ADDENDUM NUMBER 1

**Professional Development Center
and Kitchen**

For
SAN BERNARDINO CITY UNIFIED SCHOOL DISTRICT
Bid No F16-05

December 28, 2015

SECTIONS & DETAILS

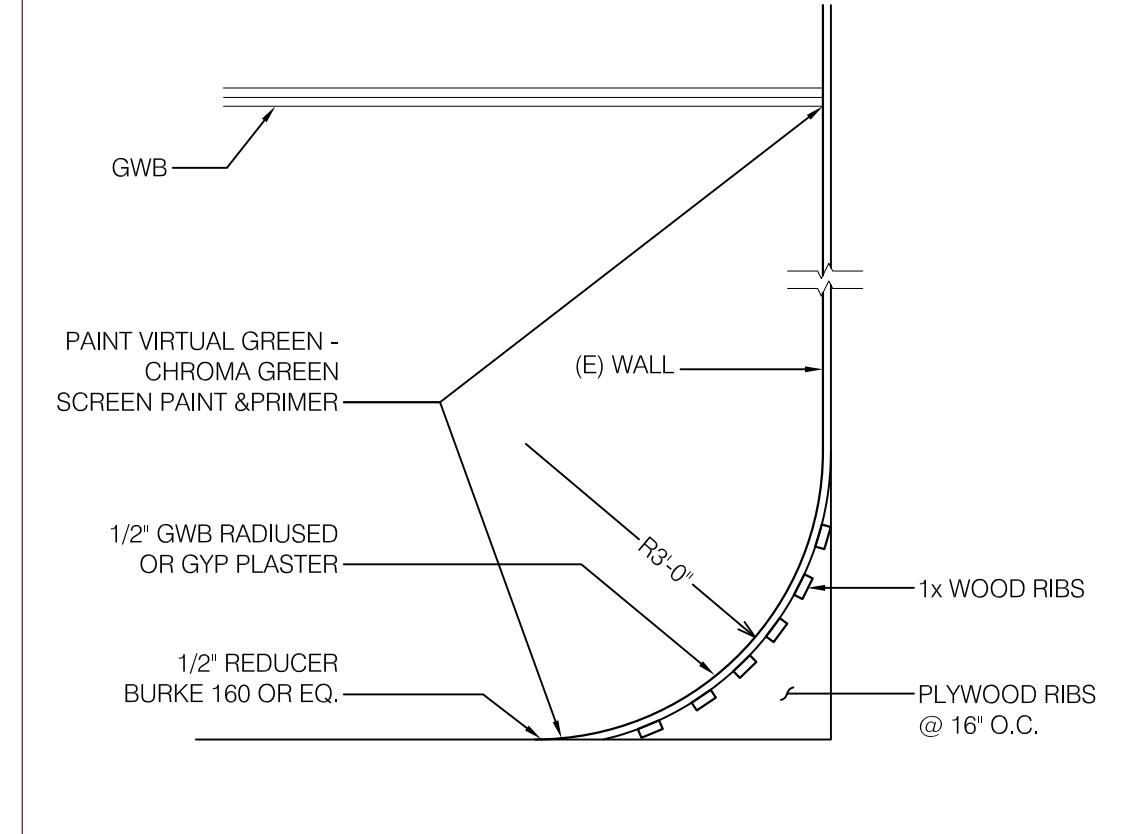
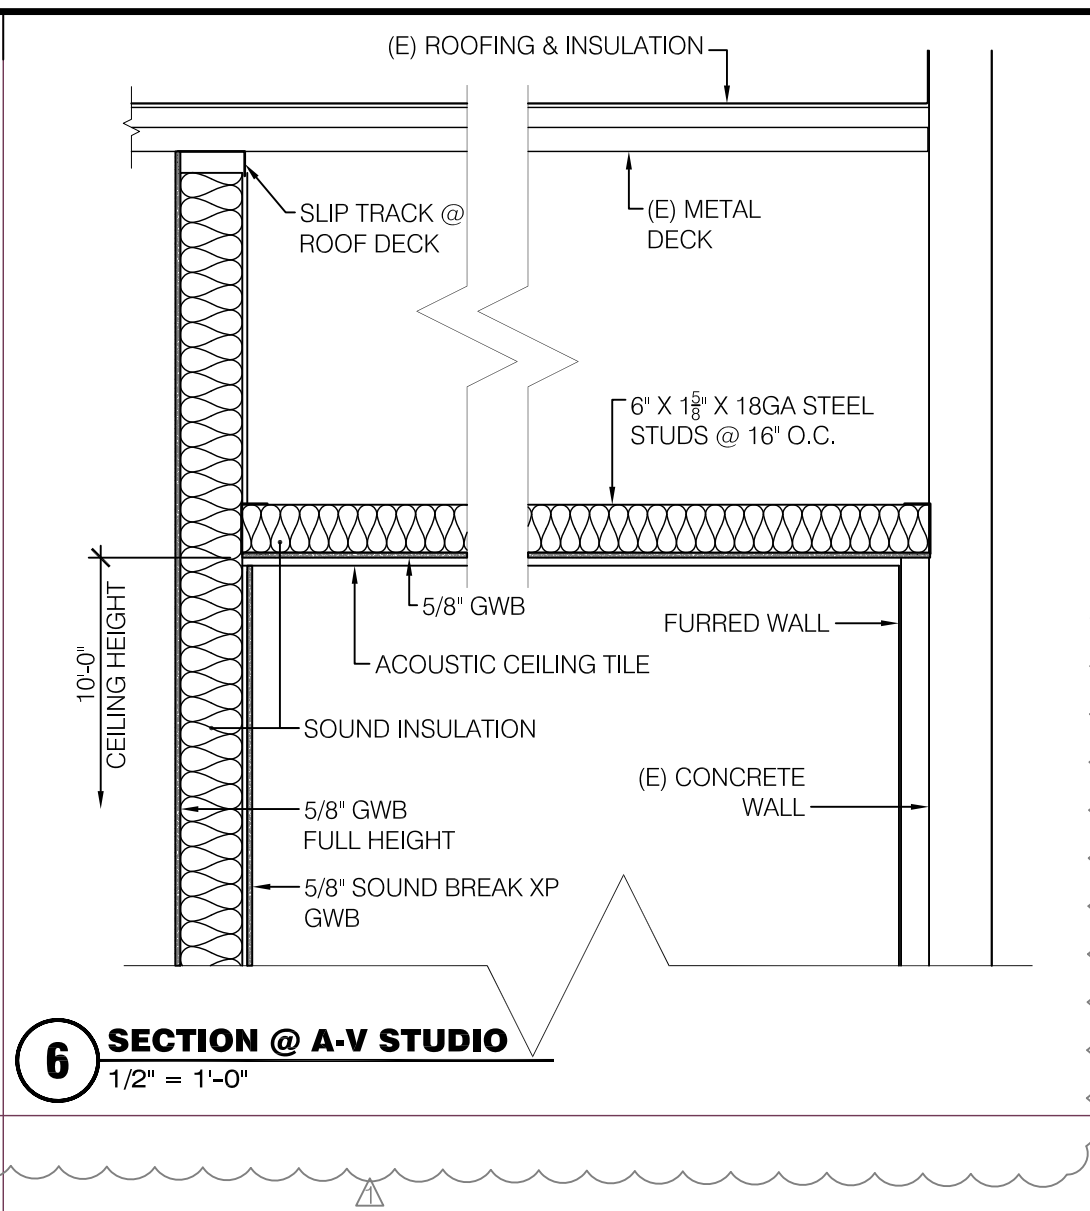
Item Number 25; Reference; Sheet A-9, Sections & Details; Replace this sheet with attached sheet **A-9, Sections & Details.**

Note: Revised sheet provides adds details 5 and 6.

PLUMBING FIRST FLOOR PLAN

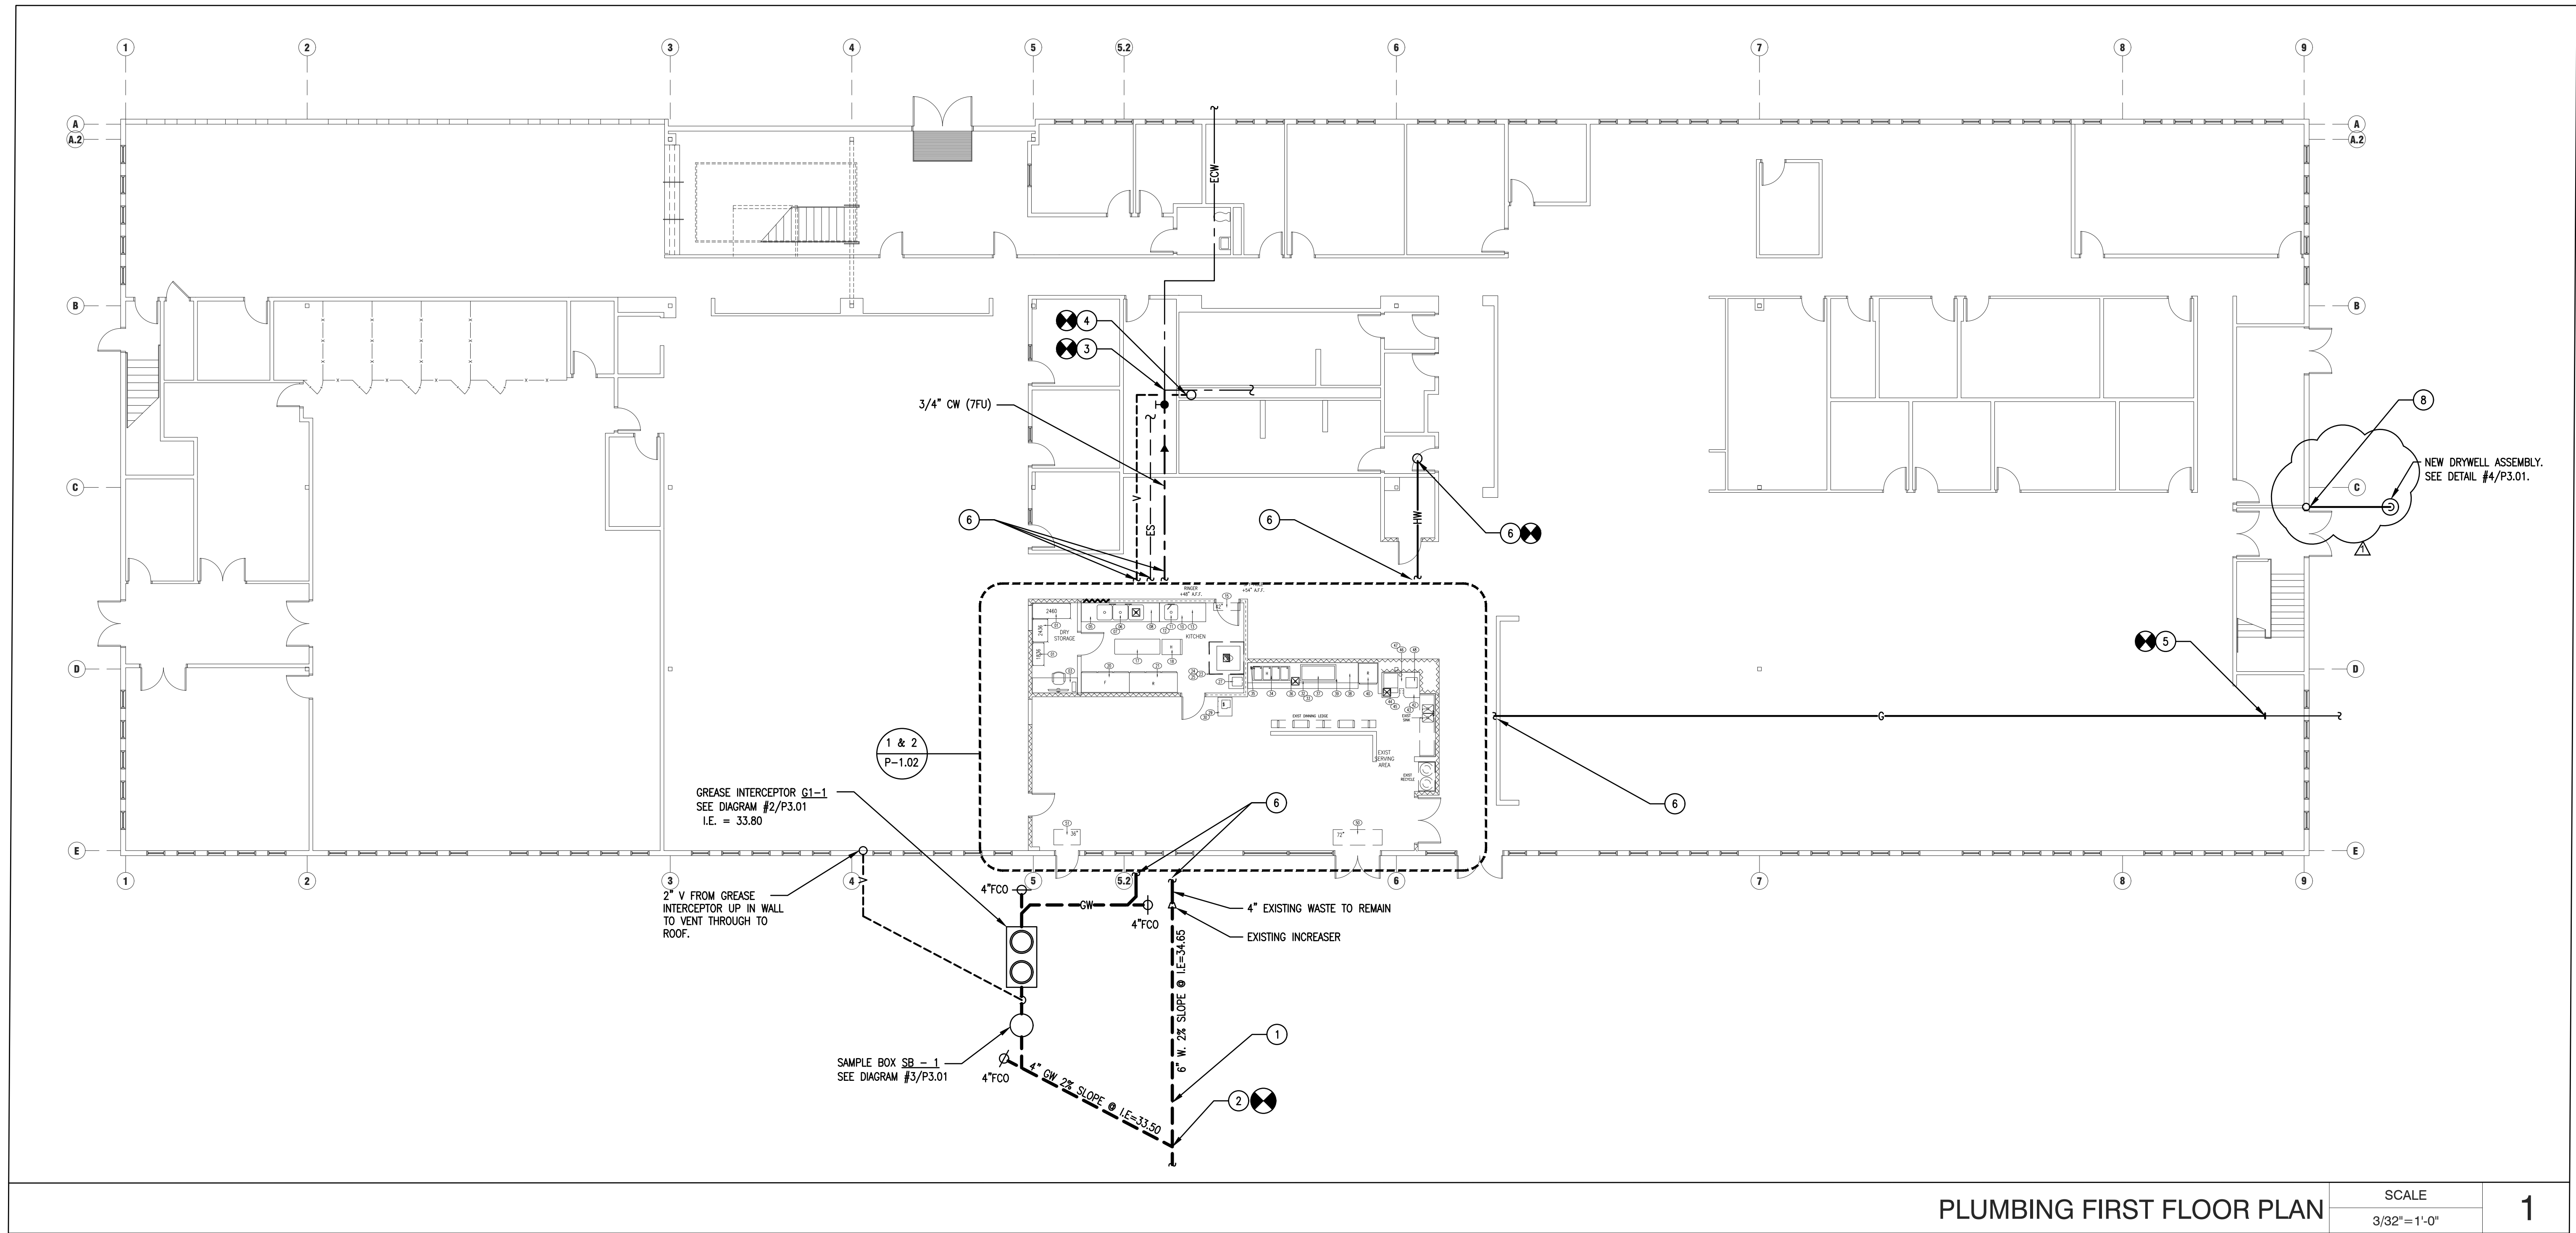
Item Number 29; Reference; Sheet P-1.01, Plumbing First Floor Plan; Replace this sheet with attached sheet **P-1.01, Plumbing First Floor Plan.**

Note: Revised sheet adds condensate drain.

PLUMBING
SECOND FLOOR PLAN

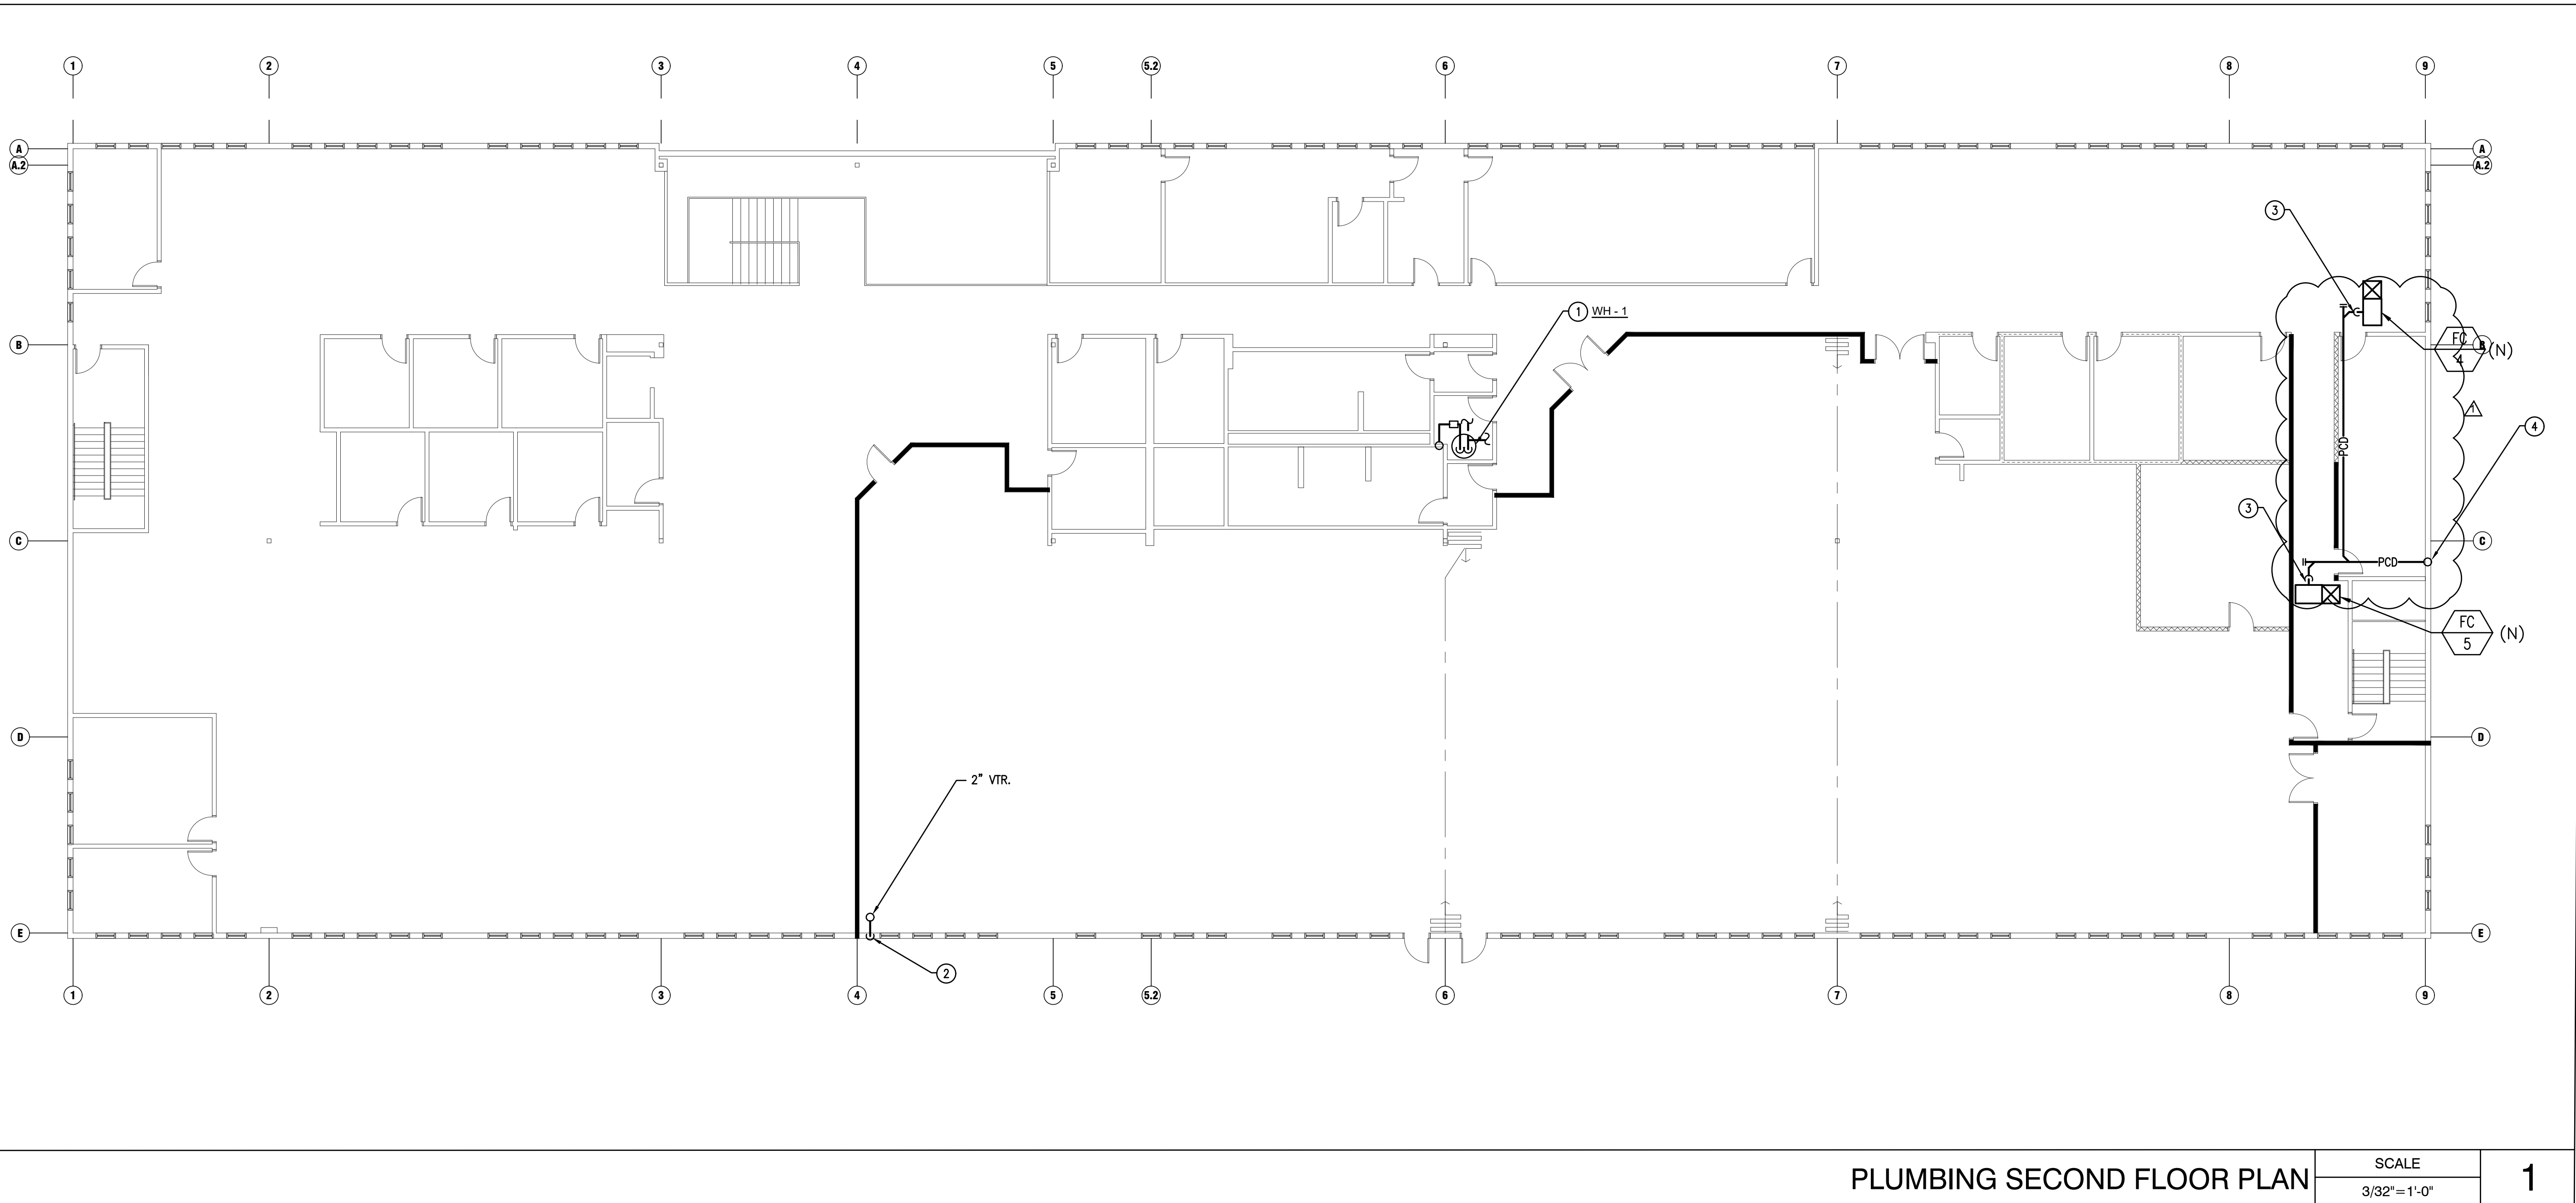
Item Number 30; Reference; Sheet P-2.01, Plumbing Second Floor Plan; Replace this sheet with attached sheet **P-2.01, Plumbing Second Floor Plan.**

Note: Revised sheet adds condensate drain.
